1 11/6/2026 - ADDENDUM NO. 1

EROSION CONTROL PLAN FOR: CASCADES BUSINESS PARK INFRASTRUCTURE IMPROVEMENTS - PHASE 1

A SITE LOCATED IN THE CITY OF NORTH BONNEVILLE, WASHINGTON

DESIGNED:	ANT
CHECKED:	JBA
NOVEMBER 2026	78260.000
SHEET ID	EC01
SHEET	5 OF 28

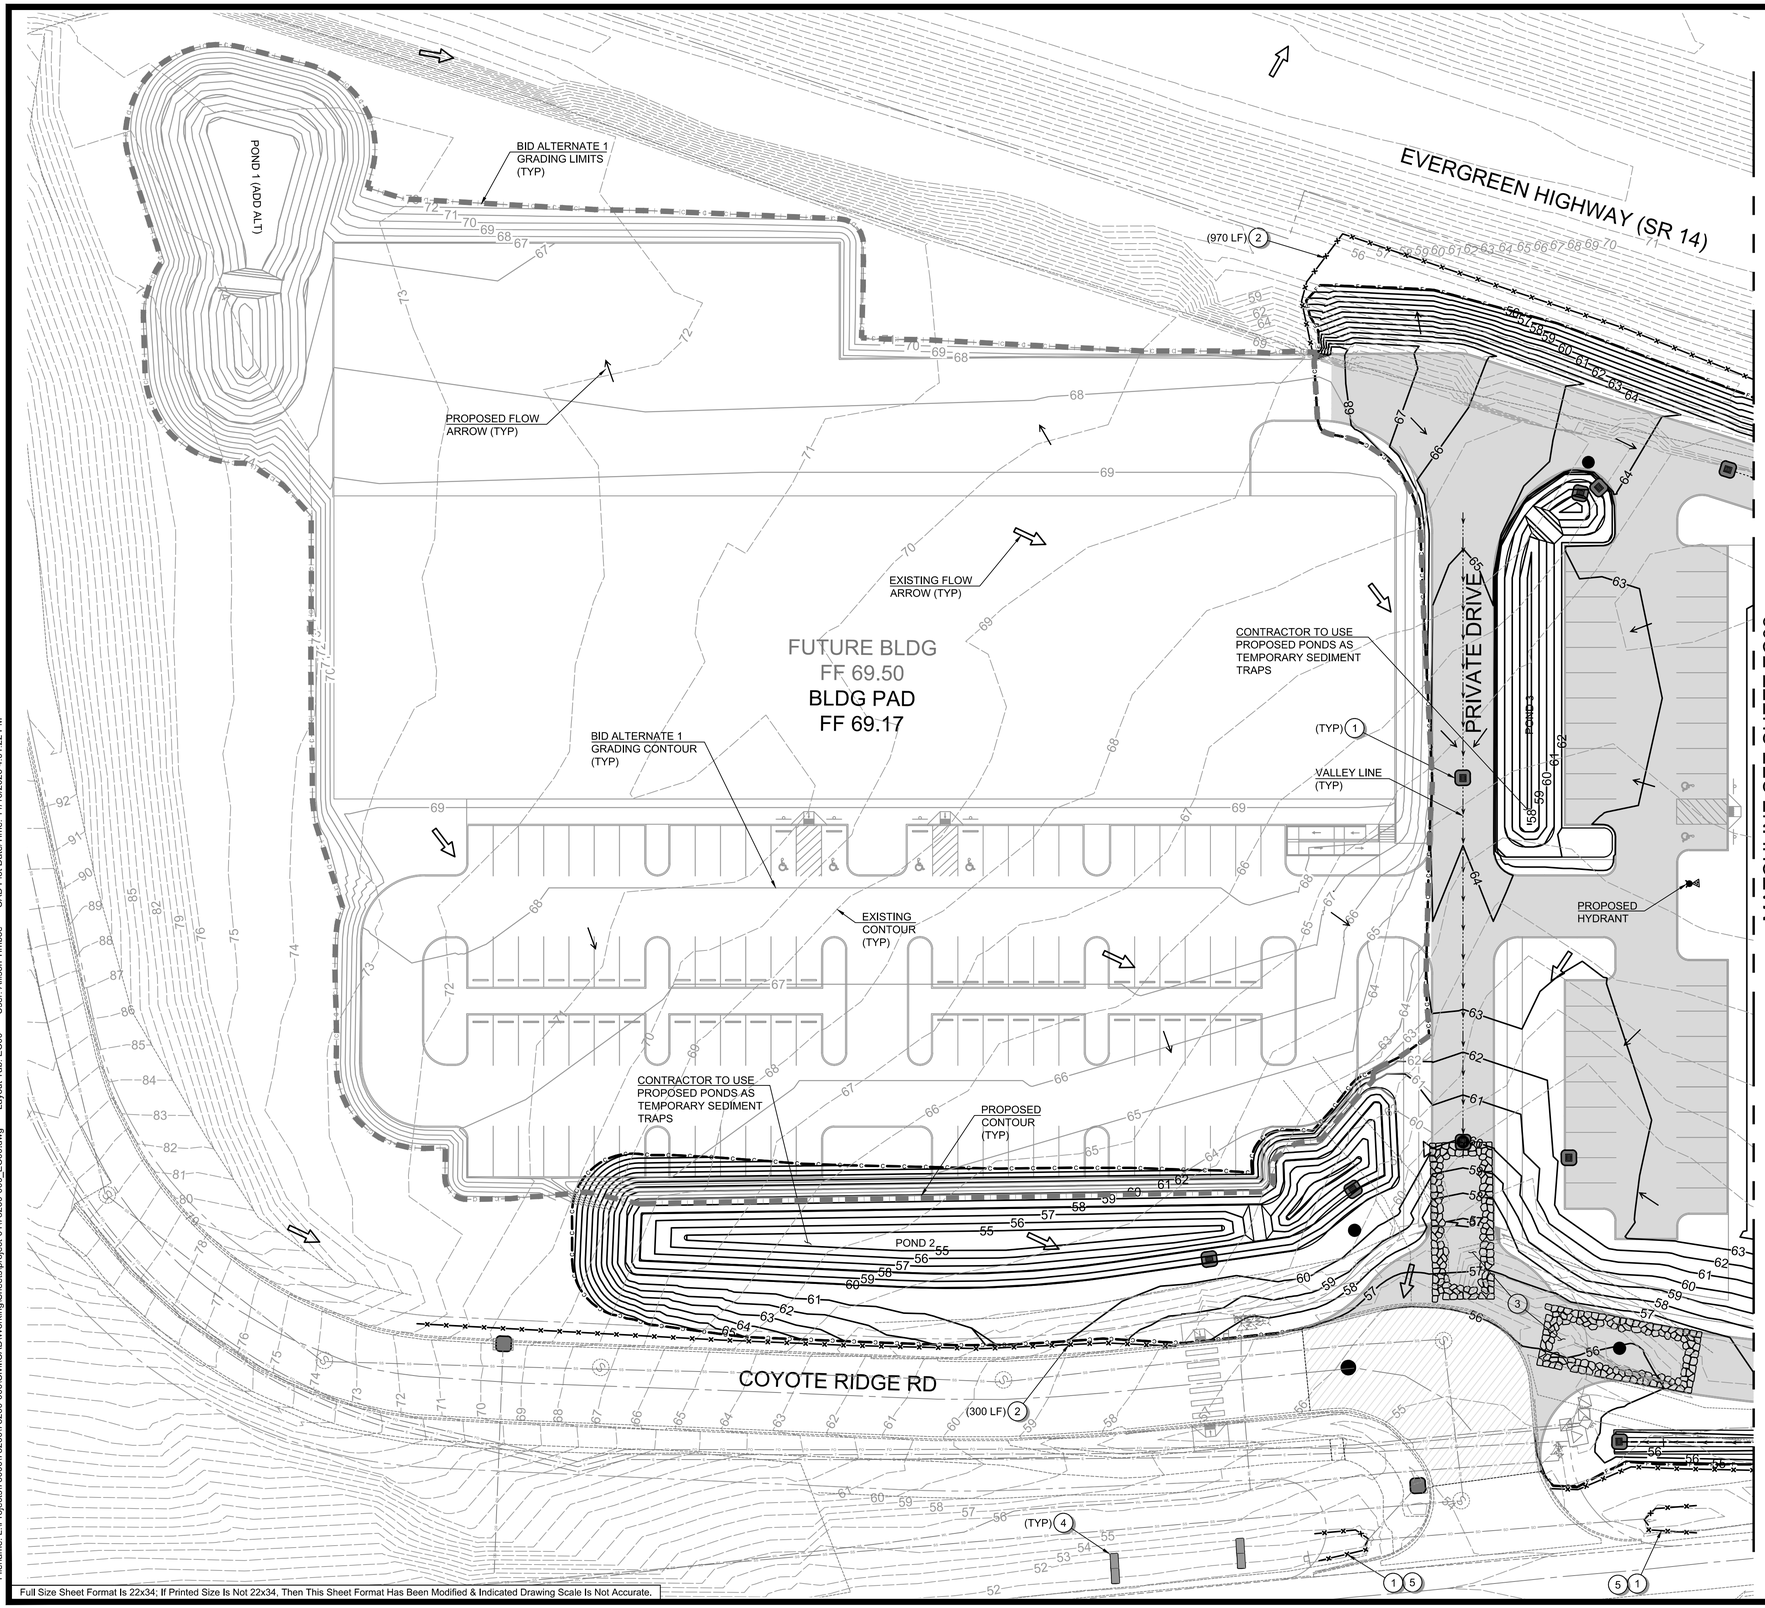
NOTE NUMBER 4 ADDED FOR CLARITY.

1. SEE SHEET G03 FOR PROJECT'S GENERAL NOTES.
2. SEE SHEET G02 FOR ABBREVIATIONS AND MASTER LEGEND.
3. CONTRACTOR TO DIRECT RUNOFF TO PROPOSED PONDS FOR TEMPORARY SEDIMENT PONDS. CONTRACTOR TO REMOVE SEDIMENT PRIOR TO POND SEEDING.
4. STABILIZE SLOPES AND BUILDING PAD AREAS WITH EROSION CONTROL SEED MIX.

SHEET ID
EC02

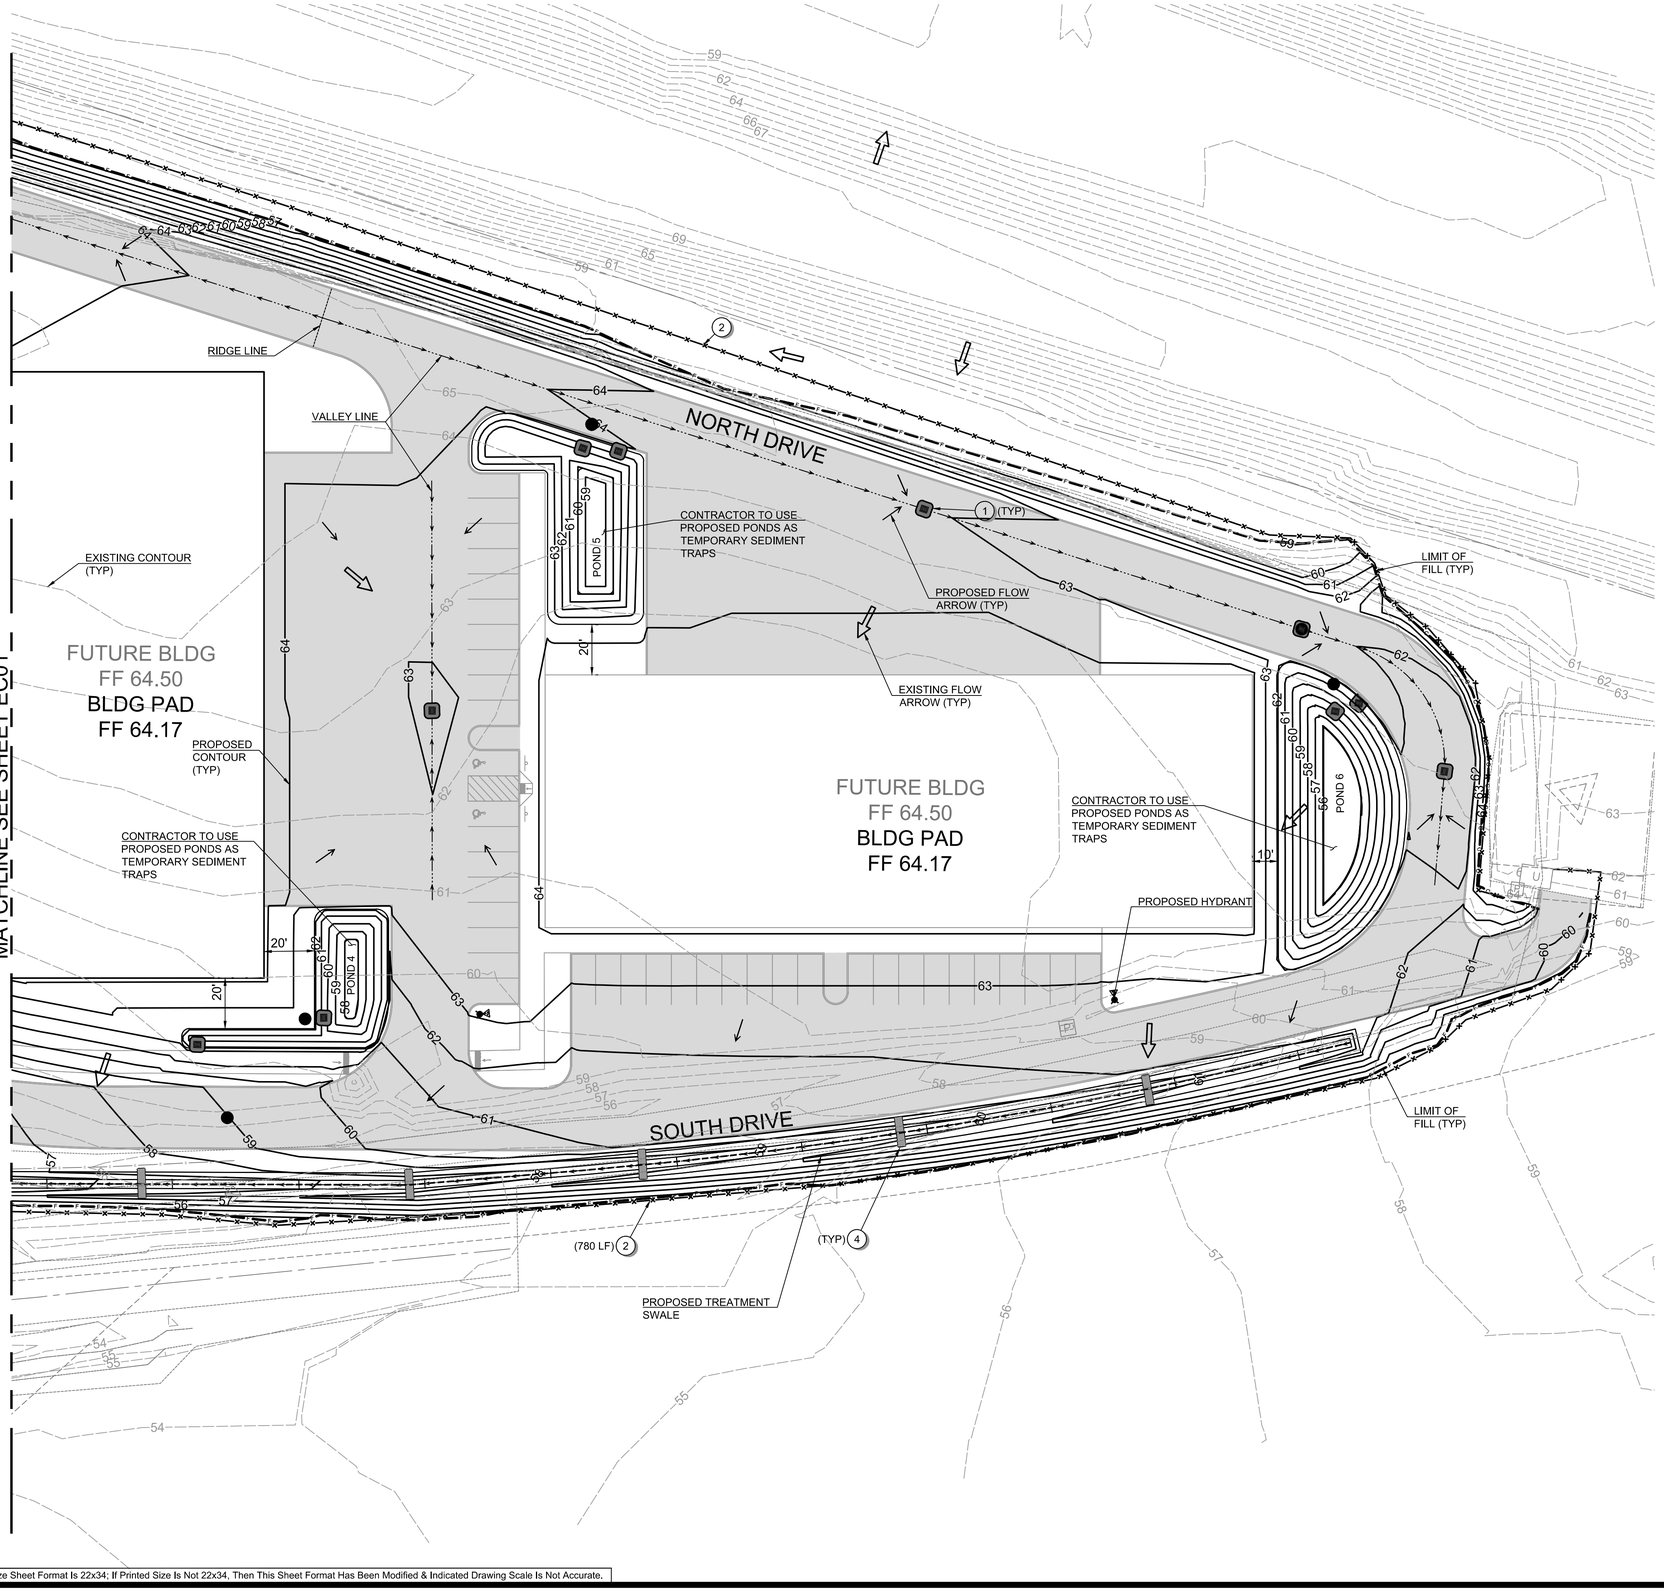
NOTE NUMBER 4 ADDED FOR CLARITY.

1. SEE SHEET G03 FOR PROJECT'S GENERAL NOTES.
2. SEE SHEET G02 FOR ABBREVIATIONS AND MASTER LEGEND.
3. CONTRACTOR TO DIRECT RUNOFF TO PROPOSED PONDS FOR TEMPORARY SEDIMENT PONDS. CONTRACTOR TO REMOVE SEDIMENT PRIOR TO POND SEEDING.
4. STABILIZE SLOPES AND BUILDING PAD AREAS WITH EROSION CONTROL SEED MIX.

SHEET ID
ST01
SHEET 11 OF 28

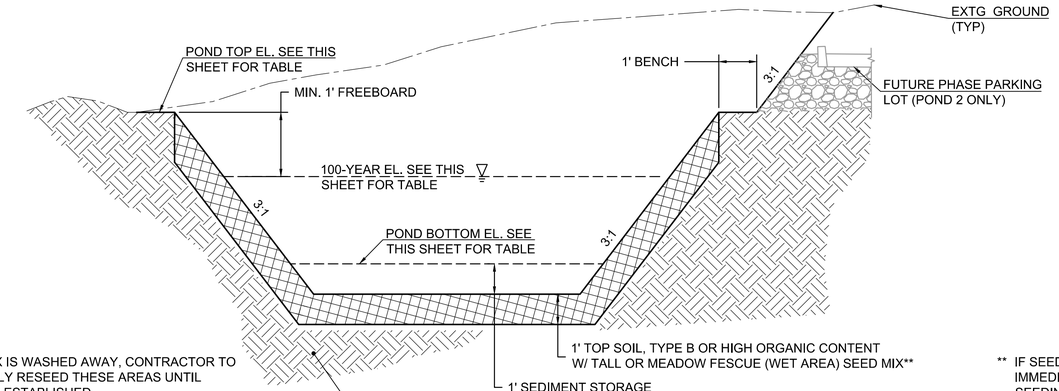
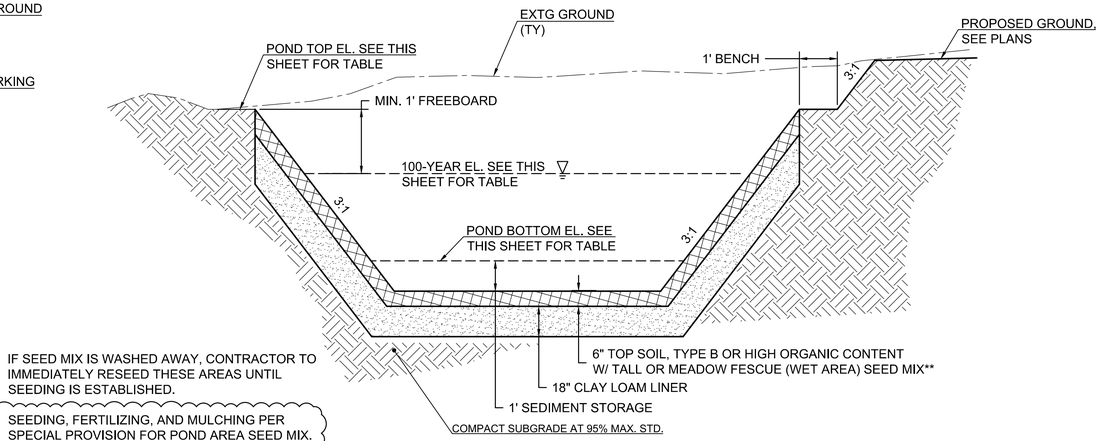
SEED MIX NOTE UPDATED FOR CLARITY.
ADDED TRENCH RESTORATION IN PAVED AREA TYPICAL SECTION.
REVISED GRIND AND INLAY SECTION

DESIGNED:	ANT
CHECKED:	JBA
NOVEMBER 2026	78260.000
SHEET ID	C01
SHEET	12 OF 28

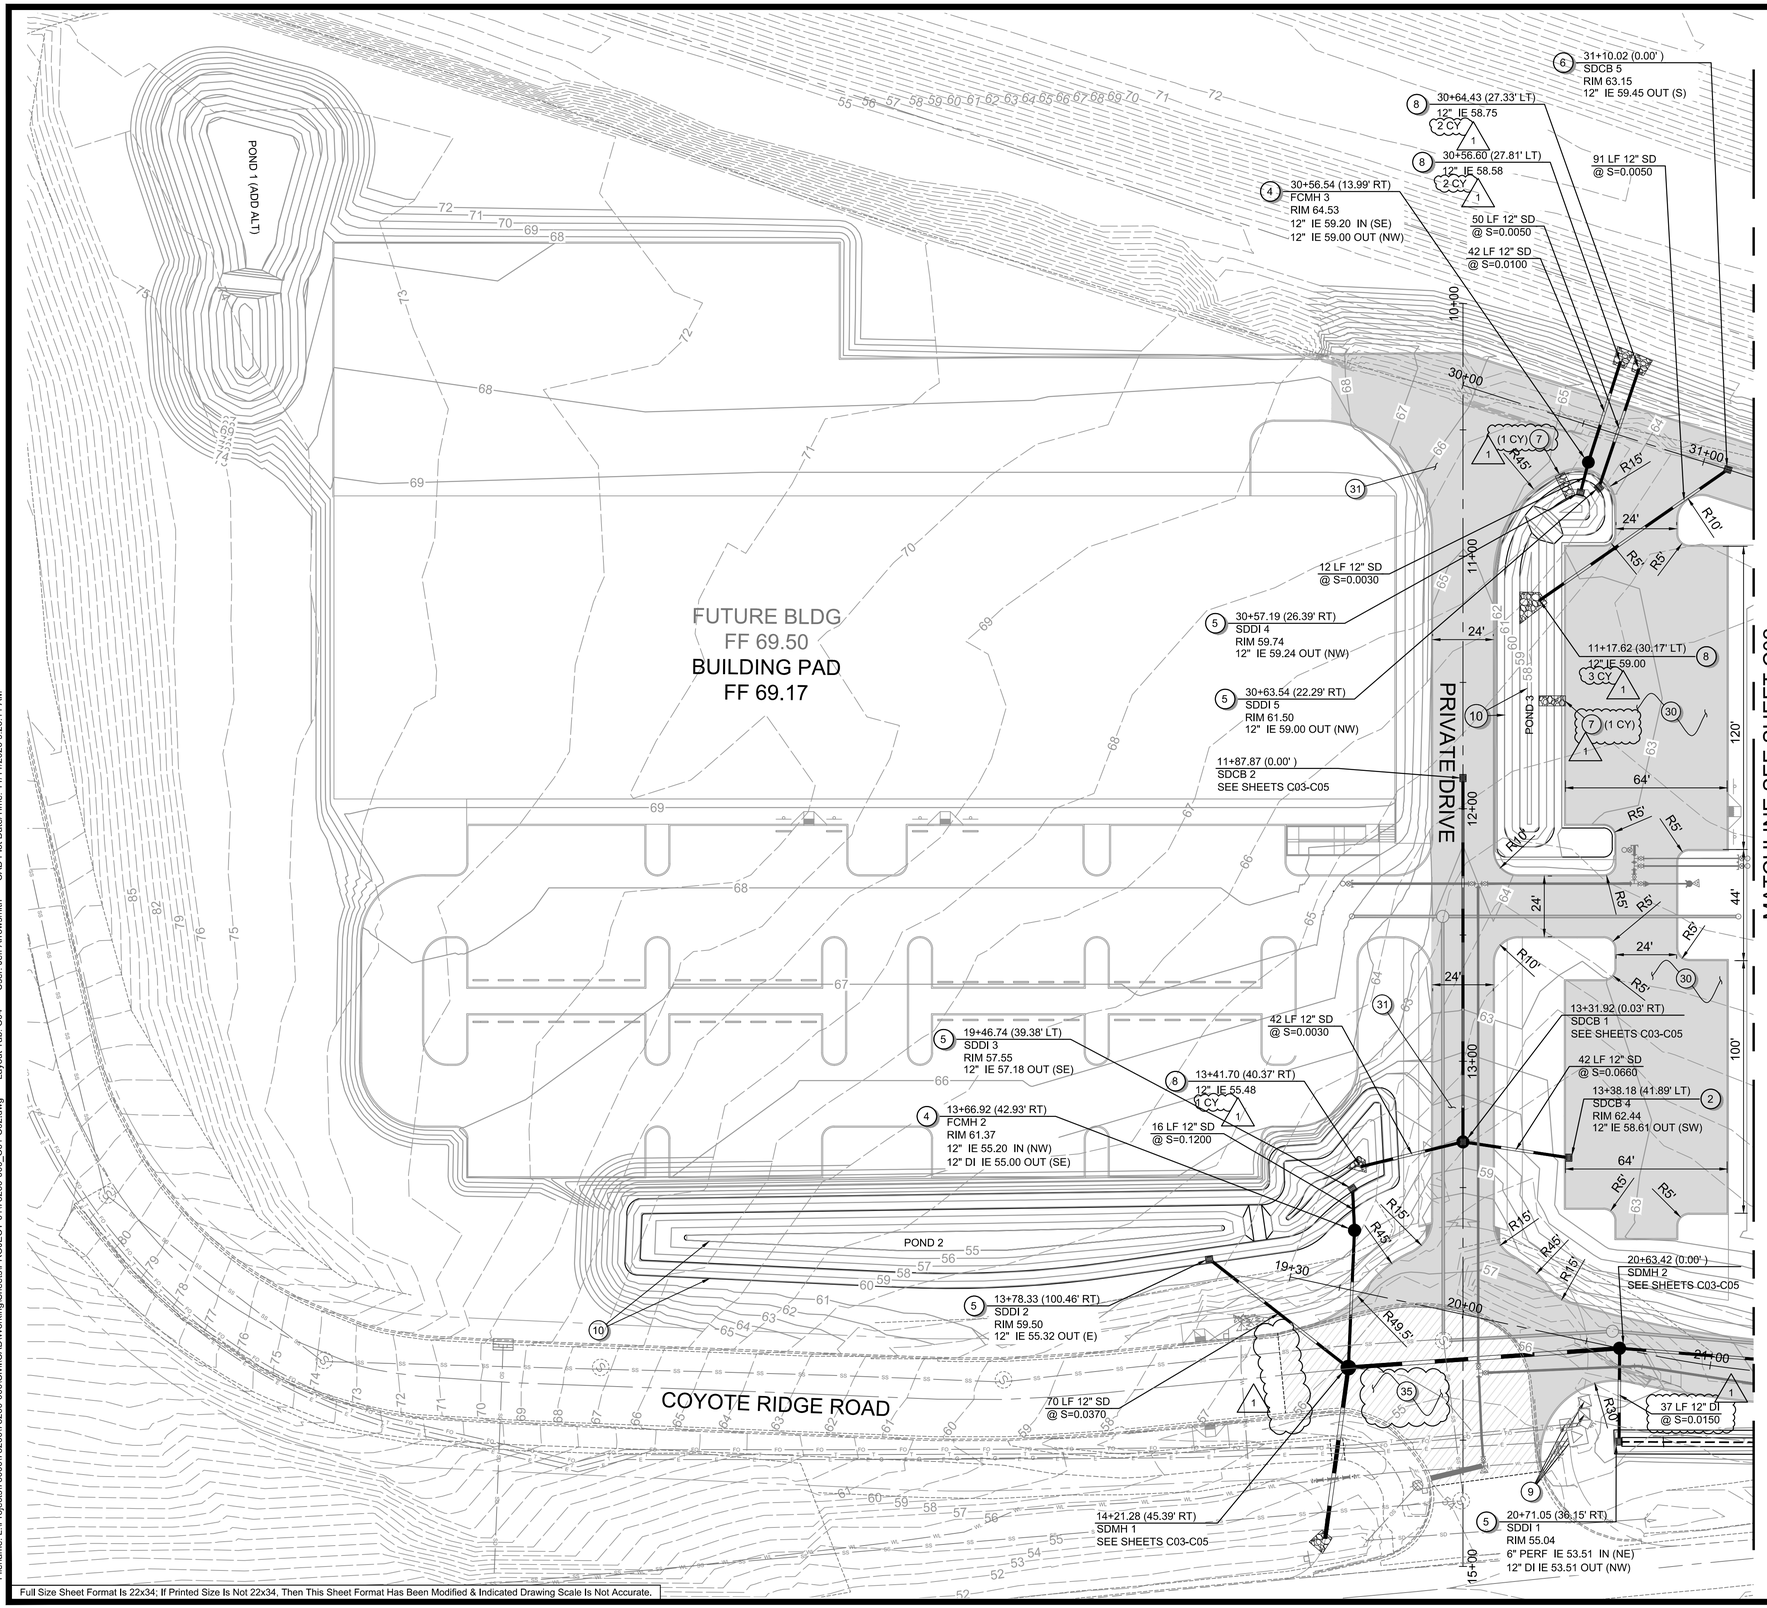
QUARRY SPALLS AND HAND PLACED RIP RAP QUANTITIES ADDED.
CONSTRUCTION NOTE NUMBER 7 WORDING CHANGED FOR POND.
37 LF OF SD PIPE CHANGED TO DI PIPE.
GRIND AND INLAY LIMITS CHANGED

5. INSTALL DITCH INLET PER DETAIL ON SHEET D01.
6. INSTALL CATCH BASIN TYPE 1 PER STANDARD PLAN B-5.20. SEE SHEET D03.
7. INSTALL 4-FOOT WIDE, 6-INCH THICK, QUARRY SPALLS PAD FROM TOP OF POND (AT LOCATION OF FUTURE CURB SCUPPER) TO BOTTOM OF POND PER DETAIL ON SHEET D01. (1)
